# UNITED STATES PATENT AND TRADEMARK OFFICE

10/734,052

Mike C. Burr

<b>Office Action Summary</b>	<b>Application No.</b>	<b>Applicant(s)</b>	
	10/734,052	BURR ET AL.	
	<b>Examiner</b>	<b>Art Unit</b>	
	Sara Addisu	3722

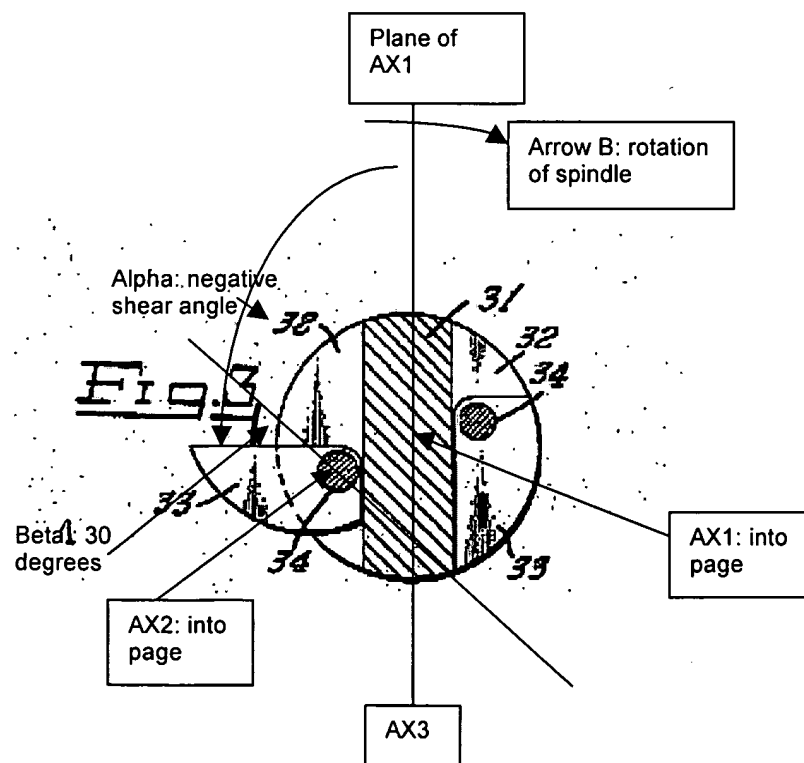
Regarding claims 1 and 20, JOHANSSON teaches a backspot facing tool comprising a shaft having a first and a second end, a recess (2) located near the first end having a first and second transverse surfaces that are generally parallel to each other and perpendicular to the first axis (as claimed in claims 8 and 27), the shaft having an outer circumference and being centered on said first axis and a cutting element (3 or 33) having an inner and outer portion and being provided with a pivot point (4: pivoting about a second axis) ('610, figures 1-3 and Col. 1, lines 52+). JOHANSSON also teaches cutter element (3) being movable between a closed position and an open position ('610, Col. 2, lines 13-16). Furthermore, JOHANSSON teaches the backspot facing tool being adapted to be rotated in a first direction (anticlockwise direction) to remove material from a workpiece and the cutting element (3) swings automatically (i.e. exhibits an over-center cam action) towards the closed position when the backspot facing tool is rotated in a second direction (clockwise) ('610, figure 2 and Col. 1, lines 18-26 and 31-44). Furthermore, regarding claim 1, JOHANSSON teaches the first axis (AX1) and the second axis (AX2: see figure below) being parallel (and therefore offset as claimed in claim 15) and with the spindle rotating in the clockwise direction (arrow B), the inner surface (A) of the cutting element forming a negative shear angle ( $\alpha$ ) with a plane intersecting the first axis (AX1) (see figure below). Regarding claims 2 and 21, JOHANSSON teaches the cutting element (3) being within an outer circumference of the shaft when in the closed position ('610, Col. 2, lines 16-18). Regarding claims 4-7 and 24-26, JOHANSSON teaches the cutting edge (that is perpendicular to AX2)

forming an angle (beta 1) with a third axis (AX3) that perpendicular to the second axis (AX2) forming an angle less than or equal to 45 degree/ 30 degrees (see figure below. Note: reading the claim broadly, the third axis (AX3) is an arbitrary line drawn such that it is perpendicular to AX2). Regarding claims 22 and 23, JOHANSSON teaches in figure 3, the cutting element having a cutting edge that is perpendicular to a second axis (axis going through pivot point of cutting element). Regarding claims 11 and 30, JOHANSSON teaches the cutting element is unitarily formed ('610, Col. 1, lines 18-19). Regarding claims 12, 13, 14 and 31, JOHANSSON teaches the cutting element being composed from carbide (a wear resistant material) as well as a removable cutting edge portion (3b) ('610, Col. 2, lines 57-59). Regarding claim 32, JOHANSSON teaches the cutting element including a removable retaining screw portion (6). Regarding claims 9, 10, 28 and 29, JOHANSSON teaches centering element (5) having a conical end surface being received in a conical bore ('610, Col. 1, line 64- Col. 2, line 6).

JOHANSSON teaches a backspot facing tool, as set forth in the above rejection. Regarding claim 35, JOHANSSON teaches the backspot facing tool being adapted to be rotated in a first direction (anticlockwise direction) to remove material from a workpiece and the cutting element (3) swings automatically towards the closed position when the backspot facing tool is rotated in a second direction (clockwise) ('610, figure 2 and Col. 1, lines 18-26 and 31-44). Regarding claim 36, JOHANSSON teaches the cutting element (3) being within an outer circumference of the shaft when in the closed position ('610, Col. 2, lines 16-18). Regarding claims 37 and 38, JOHANSSON teaches the cutting element including a removable retaining screw portion (6) that is perpendicular to AX2. Regarding claims 39-41, JOHANSSON teaches the cutting edge forming an angle (beta 1) with a third axis (AX3) that perpendicular to the second axis

(AX2) forming an angle less than or equal to 45 degree/ 30 degrees (see figure above.

Note: reading the claim broadly, the third axis (AX3) is an arbitrary line drawn such that it is perpendicular to AX2). Regarding claim 42, JOHANSSON teaches a recess (2) having a first and second transverse surfaces that are generally parallel to each other and perpendicular to the first axis. Regarding claim 43, JOHANSSON teaches centering element (5) having a conical end surface. Regarding claim 45, JOHANSSON teaches the cutting element is unitarily formed ('610, Col. 1, lines 18-19). Regarding claim 46, JOHANSSON teaches the cutting element is composed from carbide ('610, Col. 2, lines 57-59). Regarding claims 47 and 48, JOHANSSON teaches a removable cutting edge portion (3b) composed from carbide ('610, Col. 2, lines 57-59). Regarding claim 33, JOHANSSON teaches the cutting element including a removable retaining screw portion (6) (note it is well known in the art to use a screw composed of carbide because of its wear resistant composition).
